PRODUCT / PROCESS CHANGE NOTIFICATION

1.1 Company		STMicroelectronics International N.V
1.2 PCN No.		ADG/22/13213
1.3 Title of PCN		L9788 (UR66): Super High Density (SHD) NEAP Leadframe Introduction
1.4 Product Category		see list
1.5 Issue date		2022-02-16

UR66/L9788 LQFP14x14 100L EP in Muar Migration to SHD Line and NEAP

Strip size comparison

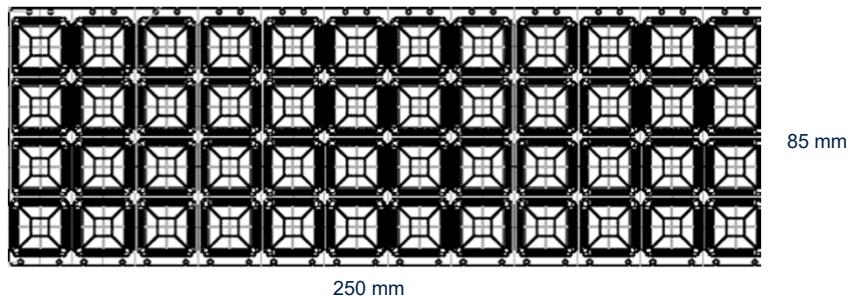
Matrix
2 x 8
16 units

SHD
4 x 12
48 units

Matrix:
5FT50149

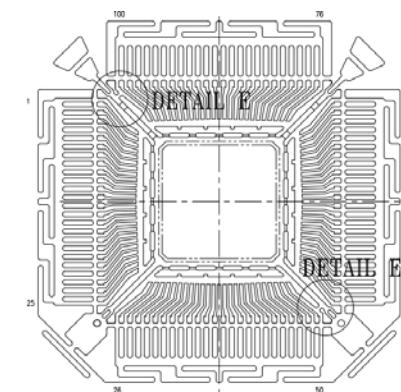
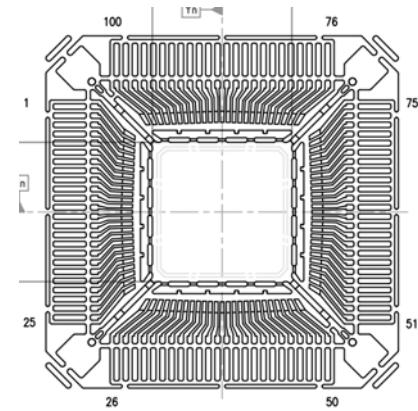
SHD:
5FT90119

No changes in unit geometry. Only change strip size

Mold Injection Gates

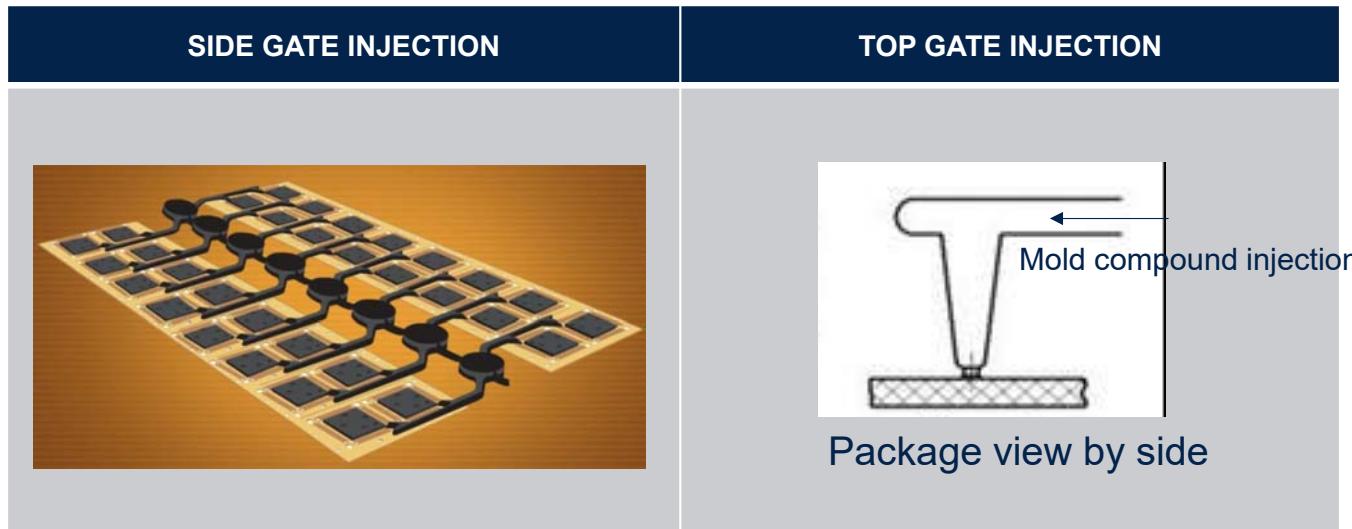
Same Basic Technology - Transfer Molding

Dummy Sample

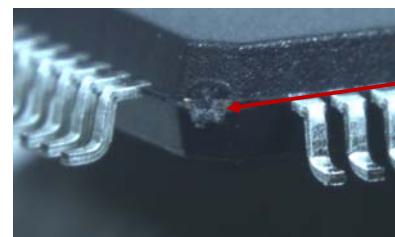
Gate Injection Notch
